# A303 Amesbury to Berwick Down

**Deadline 2**  
**8.10.14 Noise and Vibration Effects (Ns.1)**

#### Noise and Vibration Effects (Ns.1)

<b>Regulation Number:</b>	Regulation 5(2)(g)
<b>Planning Inspectorate Scheme Reference</b>	TR010025
<b>Application Document Reference</b>	8.10.14
<b>Author:</b>	A303 Amesbury to Berwick Down Project Team, Highways England

HE551506-AMW-DR-GI-00597 plan of chainages Ns.1.16

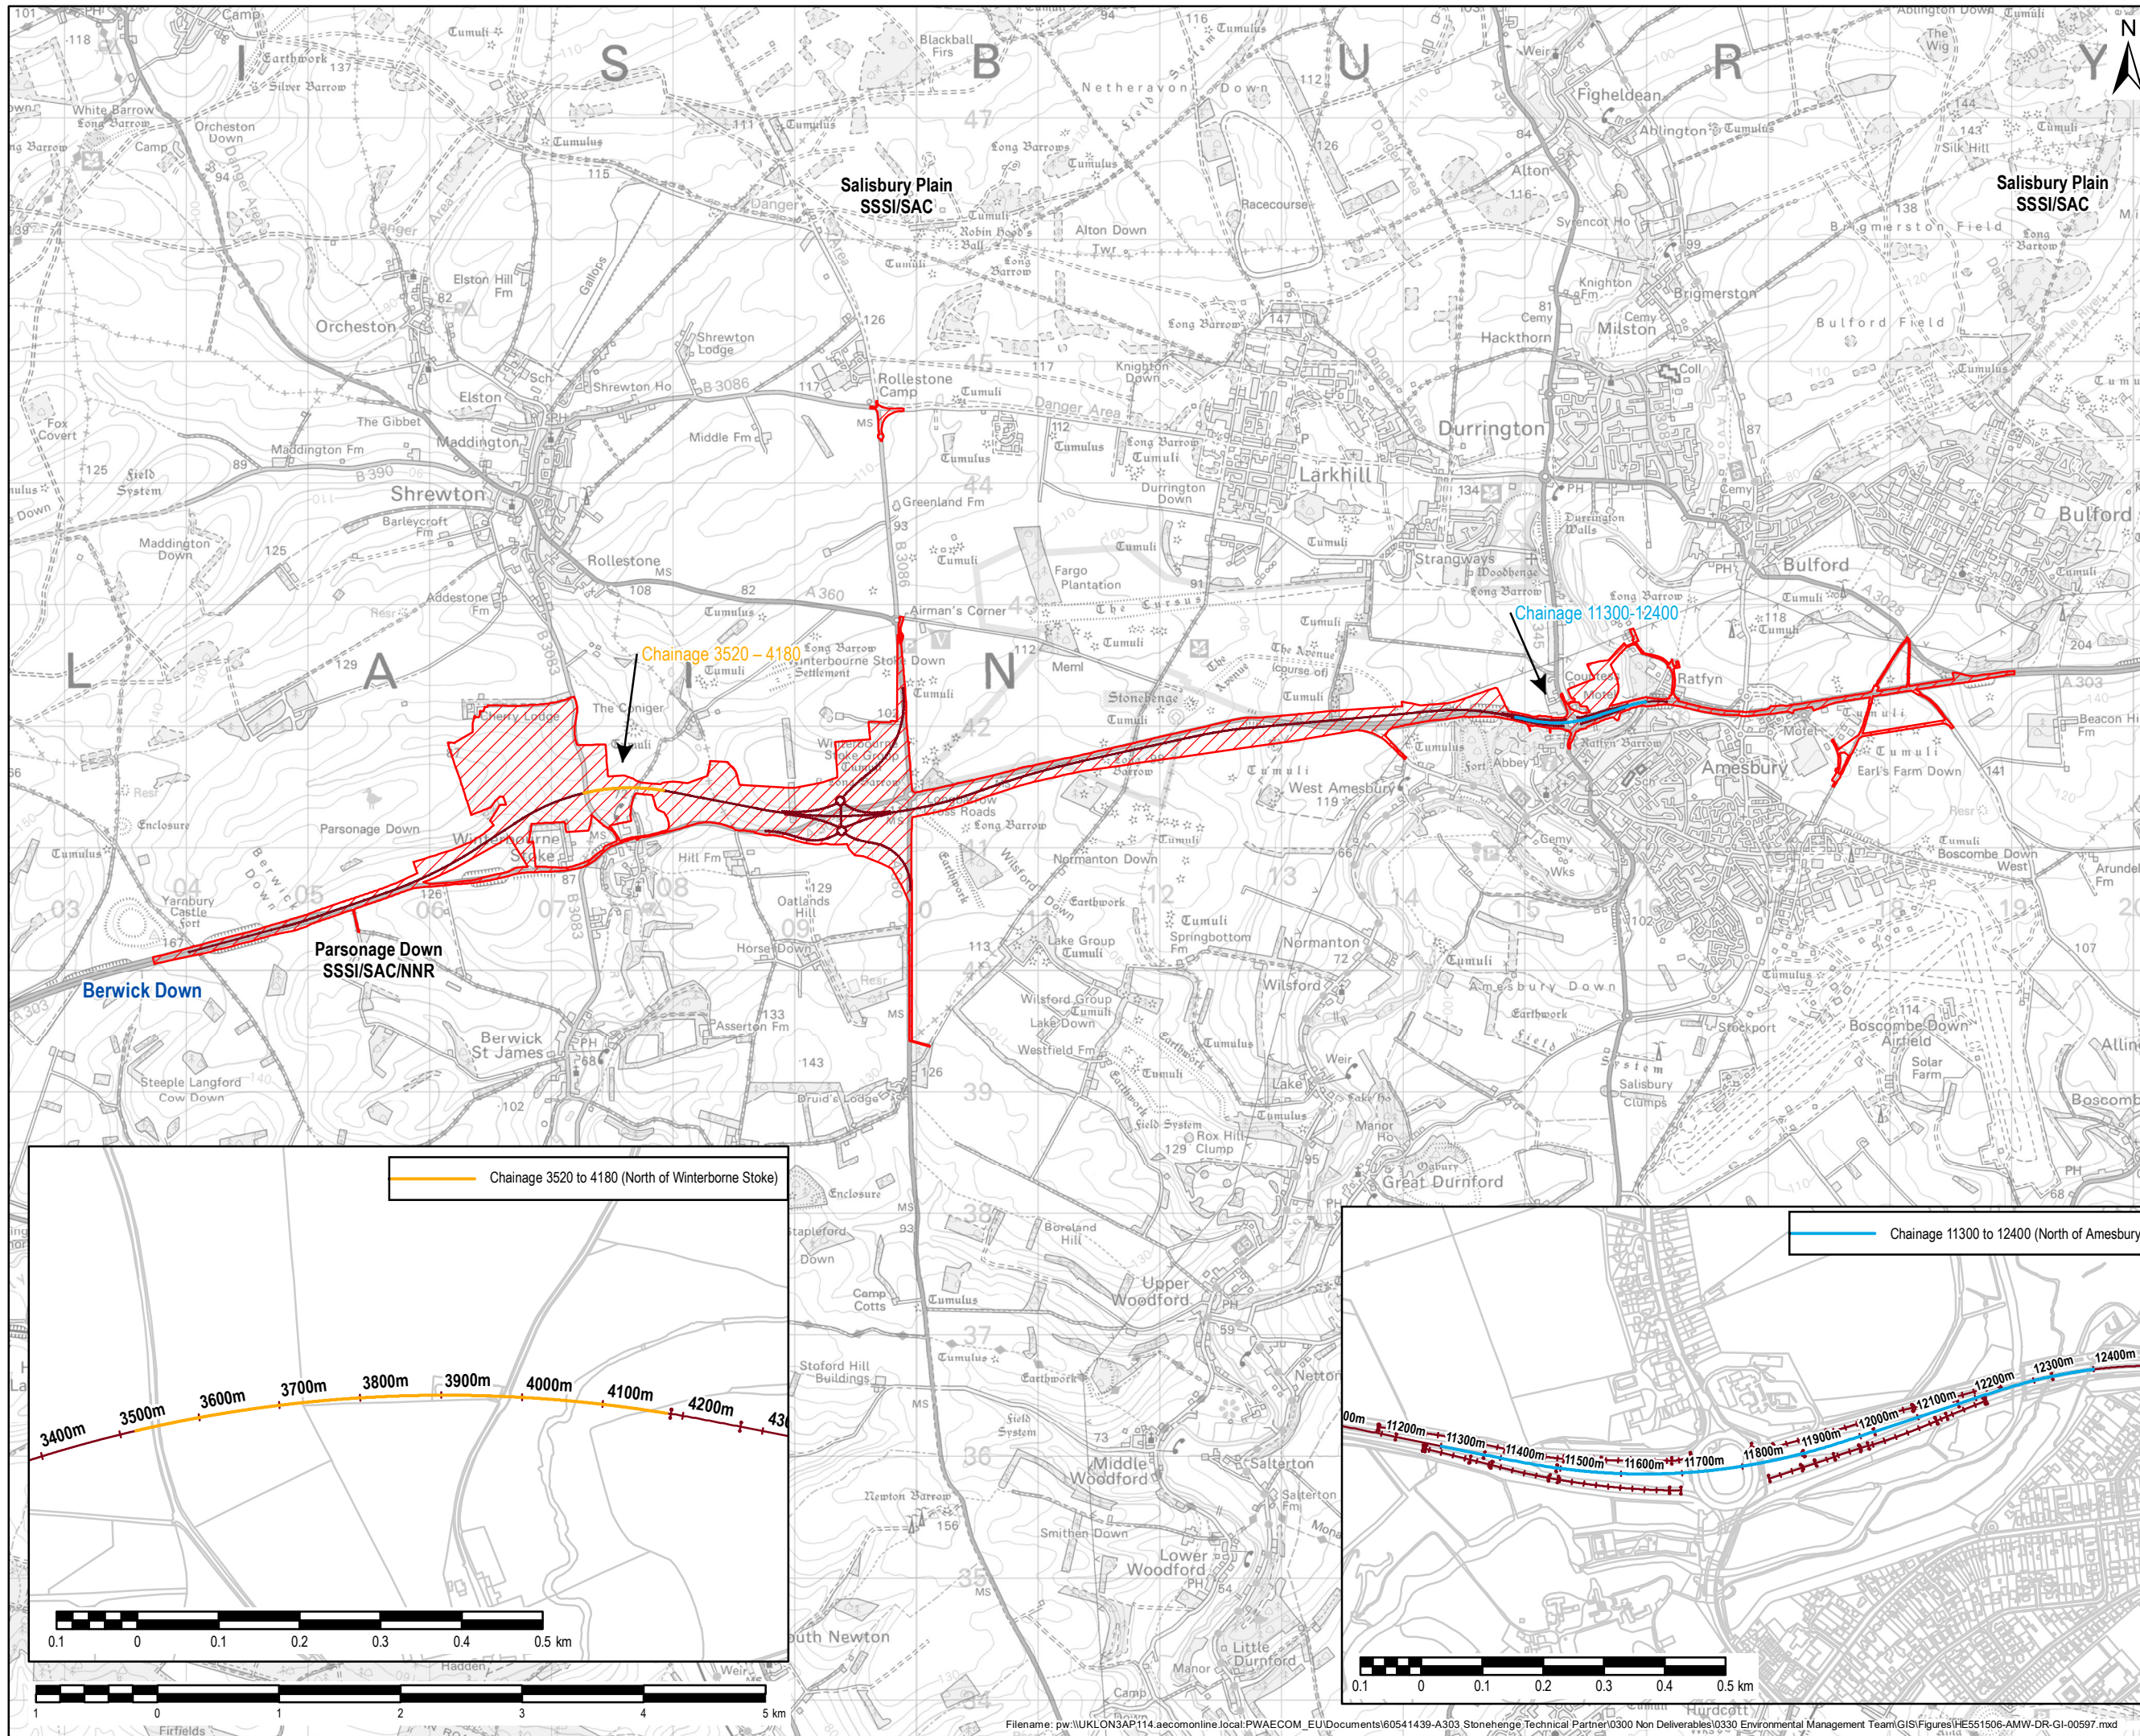
Could the Applicant provide a plan with measurements and justification for the distinction in working hours in the proximity of Countess Roundabout, and River Till Viaduct so that the ExA can understand what is understood by 'in the vicinity of'?

1. Site specific working hours for the main works are required within Chainage 3520 to Chainage 4180 and Chainage 11300 to Chainage 12400 i.e. Winterbourne Stoke (River Till) and Amesbury (Countess), as set out in MW-G13 of the Outline Environmental Mitigation Plan [APP-048], compliance with which is secured pursuant to paragraph 4 at Schedule 2 of the dDCO. Plan 'HE551506-AMW-DR-GI-00597 Chainages of working hours 07:30-18:00 Monday – Friday and 07:30-13:00 Saturday' illustrates these chainages. These chainages were identified as appropriate locations to apply reduced working hours, as they cover the closest approach of the works to areas of large numbers of residential properties i.e. Amesbury and Winterbourne Stoke. Only a small number of individual properties are located outside of these chainages.

HE551506-AMW-DR-GI-00598 plan of thin surfacing Ns.1.26

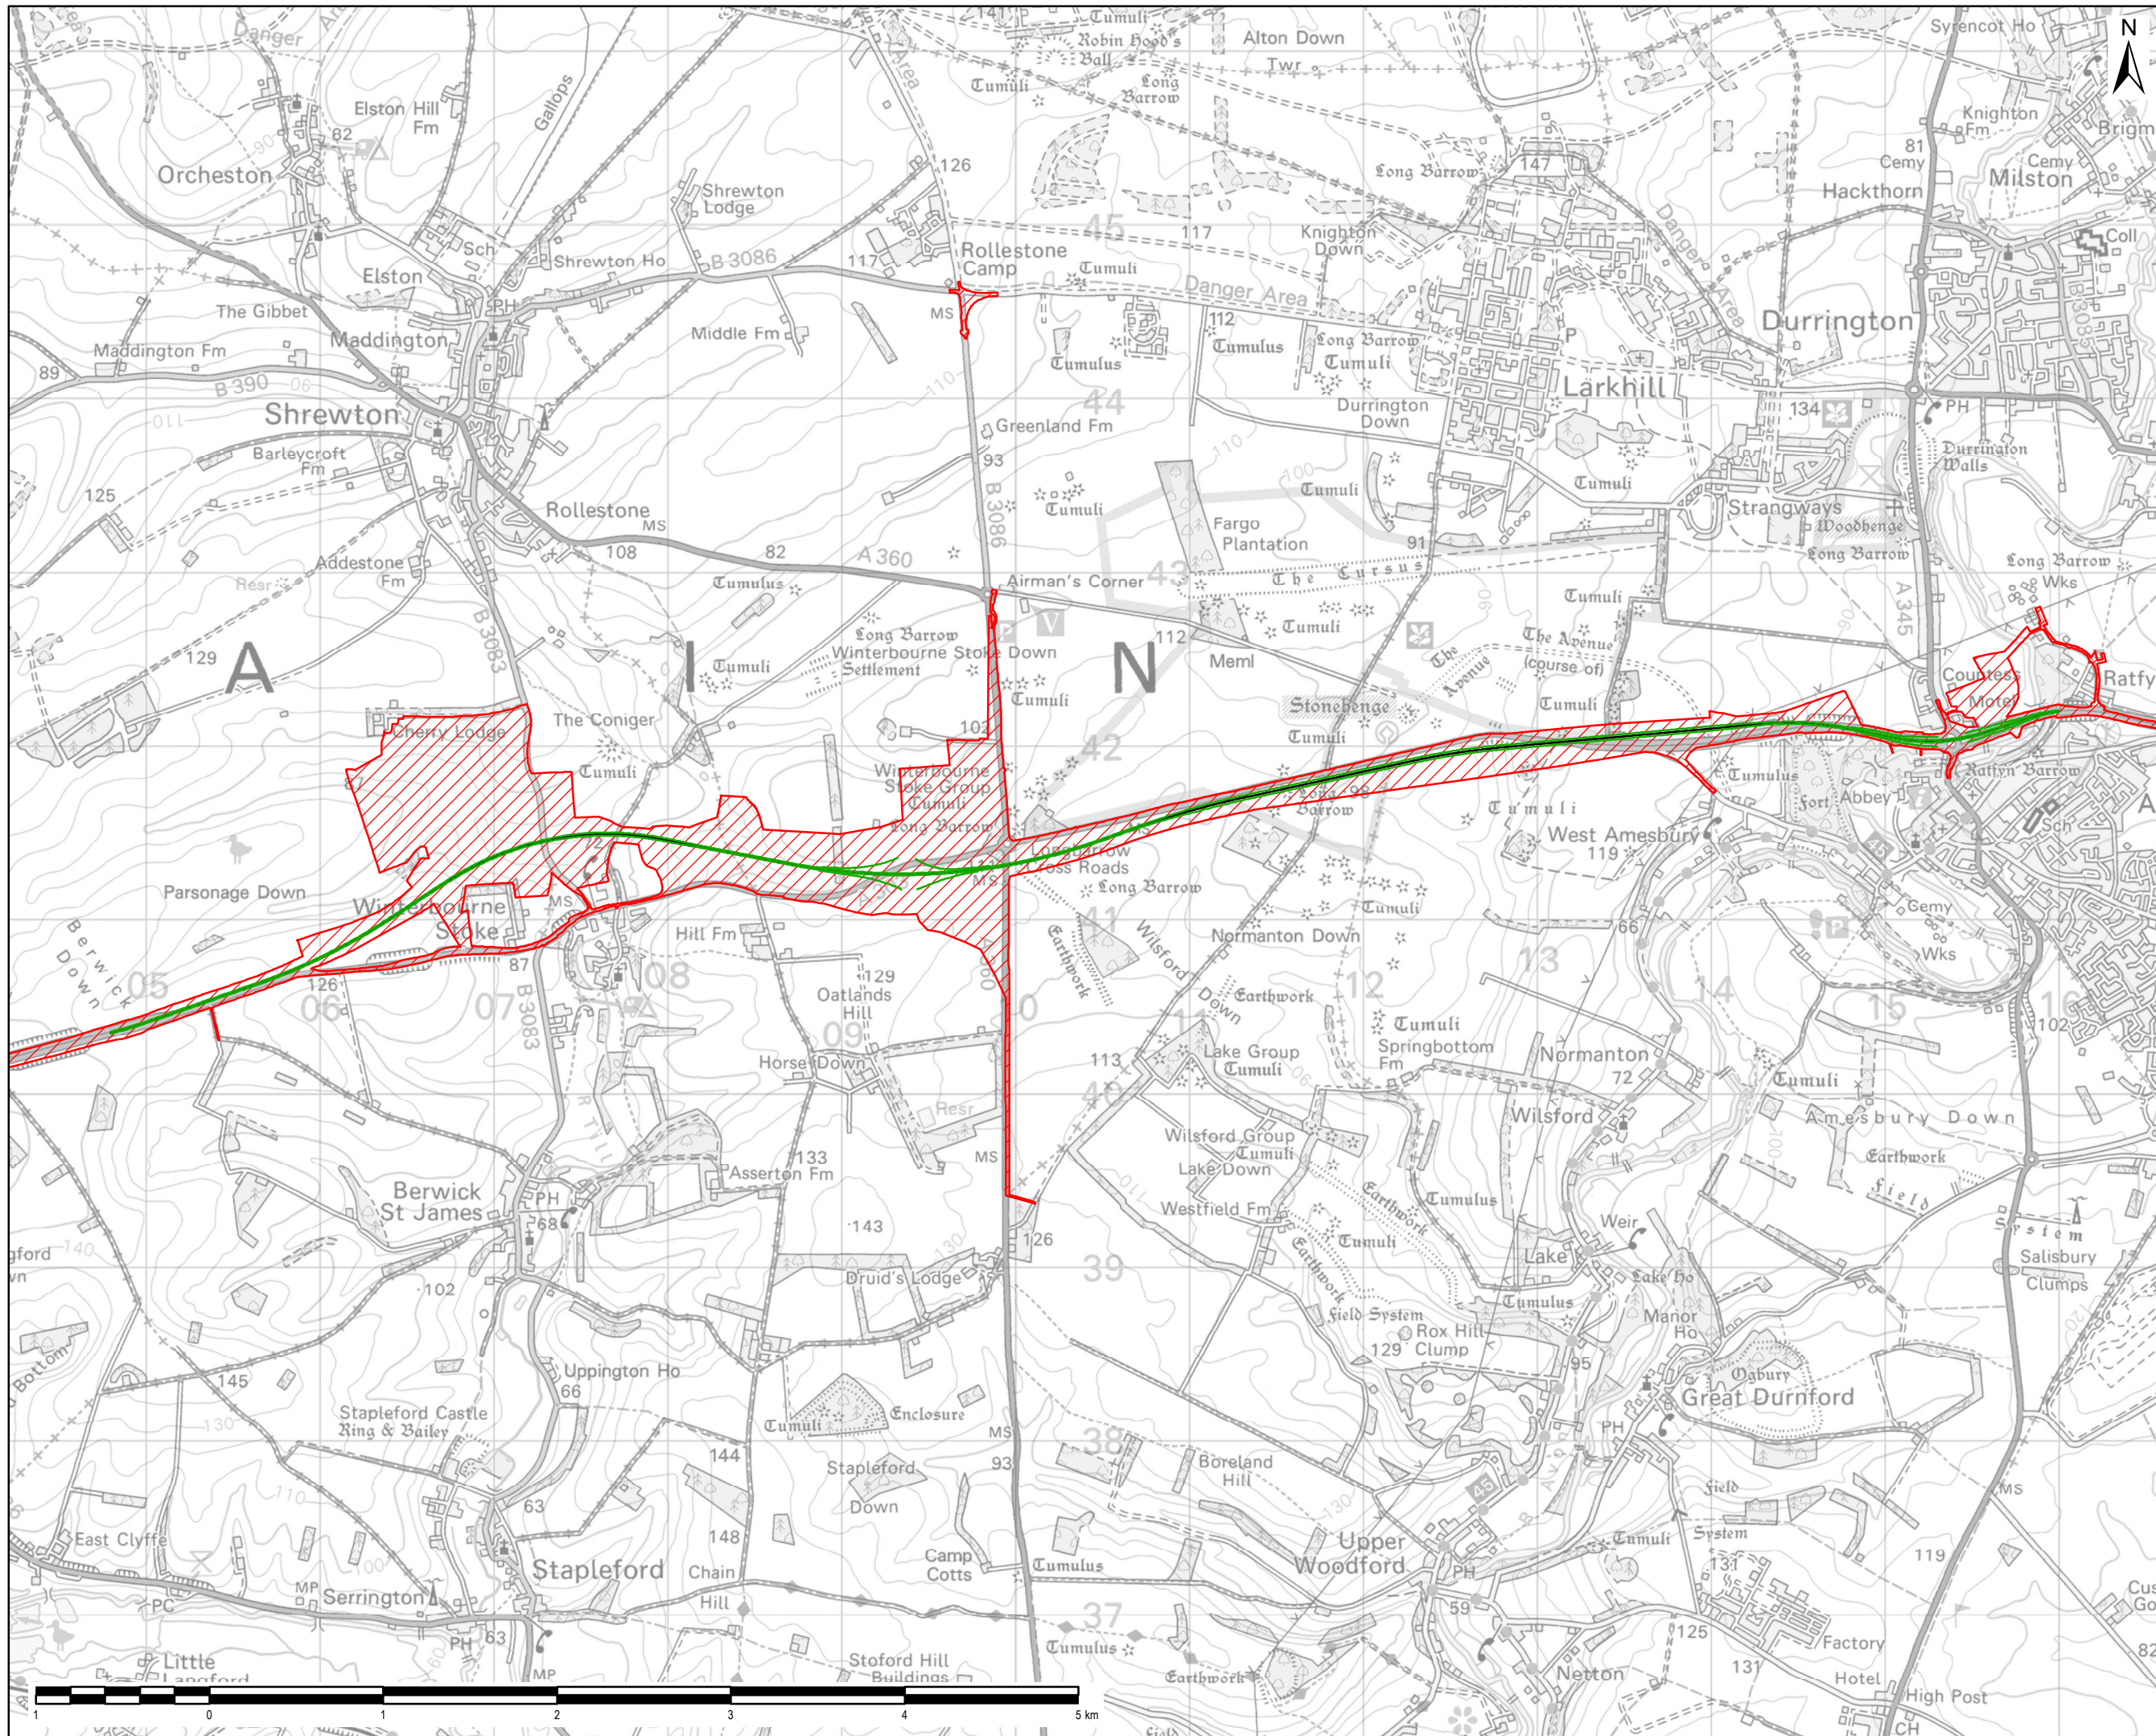
Please provide a plan showing the lengths of road this is proposed for.

1. The thin surfacing is proposed on the mainline and slip roads within the scheme extent. Please see plan 'HE551506-AMW-DR-GI-00598 Location of Thin Surfacing'. As detailed in paragraph 9.4.3 of the ES Noise and Vibration chapter [APP-047], the benefit of such surfacing is achieved at higher speeds ( $\geq 75\text{km/hr}$ ) where noise from the interaction of the tyre with the road surface dominates over engine noise. Therefore it is not essential on low speed roads such as roundabouts.
